UNITED STATES  
DEPARTMENT OF THE INTERIOR  
BUREAU OF LAND MANAGEMENTNM OIL CONSERVATION  
ARTESIA DISTRICT  
NOV 28 2018  
RECEIVEDFORM APPROVED  
OMB NO. 1004-0137  
Expires: January 31, 2018**SUNDRY NOTICES AND REPORTS ON WELLS**  
*Do not use this form for proposals to drill or to re-enter an abandoned well. Use form 3160-3 (APD) for such proposals.***SUBMIT IN TRIPLICATE - Other instructions on page 2**

| 4. Location of Well (Footage, Sec., T., R., M., or Survey Description)<br>Sec 20 T17S R30E NENE 330FNL 330FEL                    |   | 8. Well Name and No.<br>W D MCINTYRE C 2                      |
|  |   | 9. API Well No.<br>30-015-04226-00-S1                         |

**\*\* BLM REVISED \*\* BLM REVISED \*\* BLM REVISED \*\* BLM REVISED \*\* BLM REVISED \*\***

W D McIntyre C #2

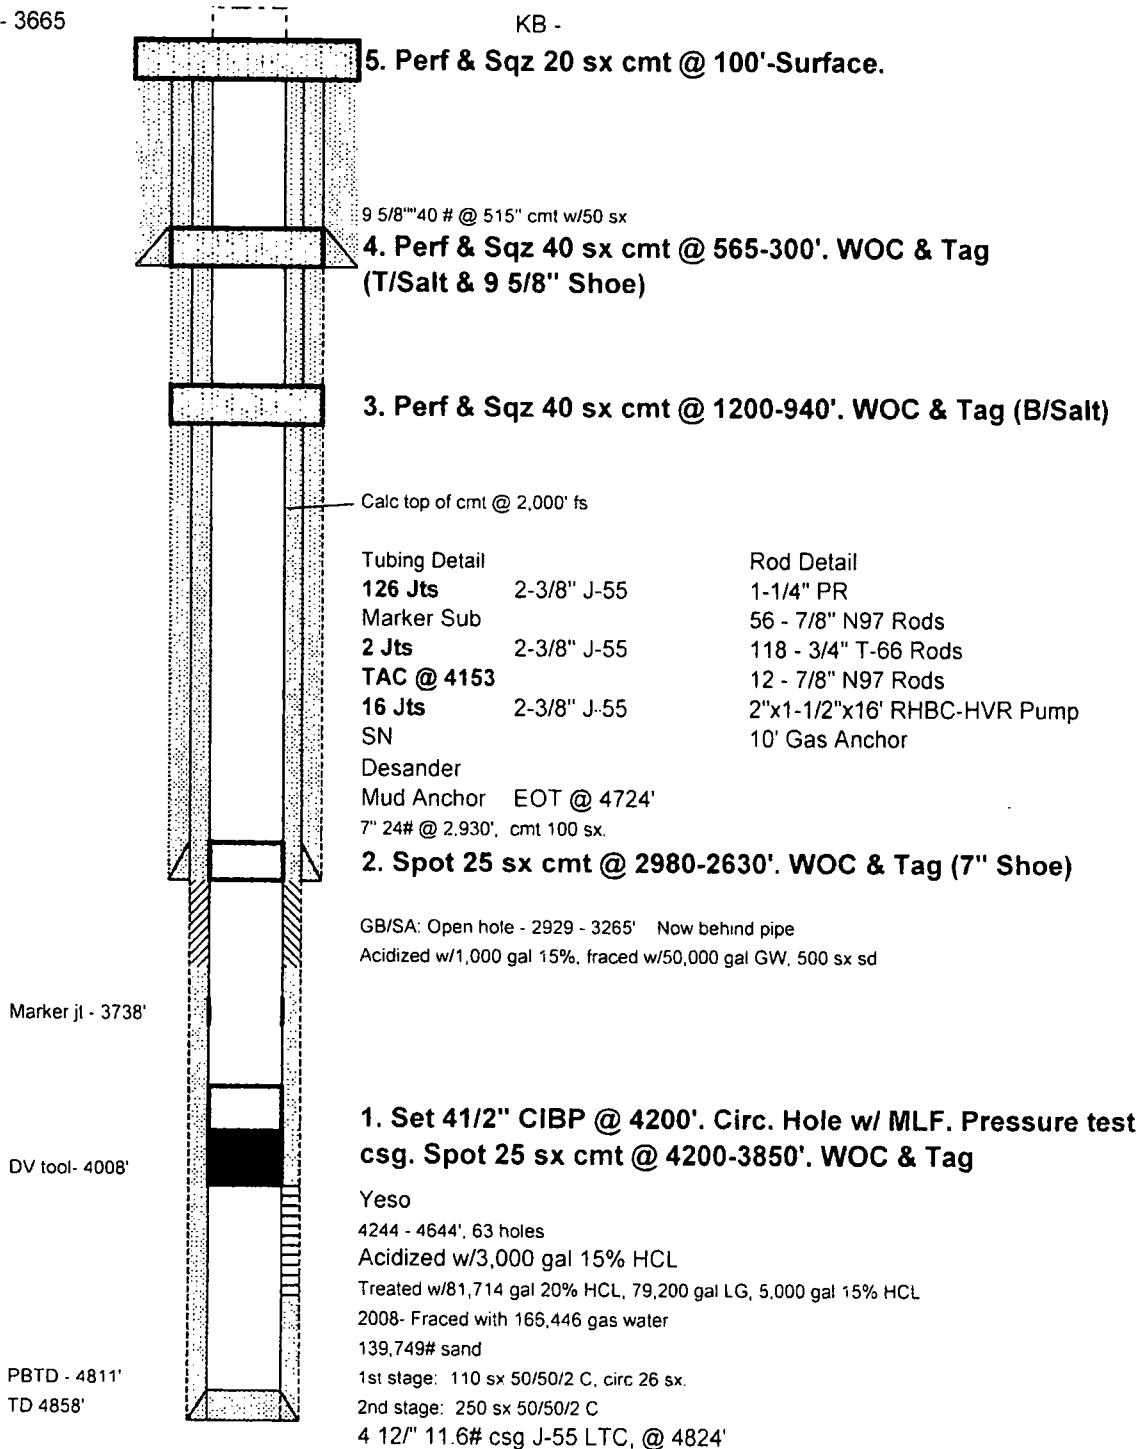
all annulus.

utilize deep penetrating slots  
Perf both 7" & 4 1/2" csg.
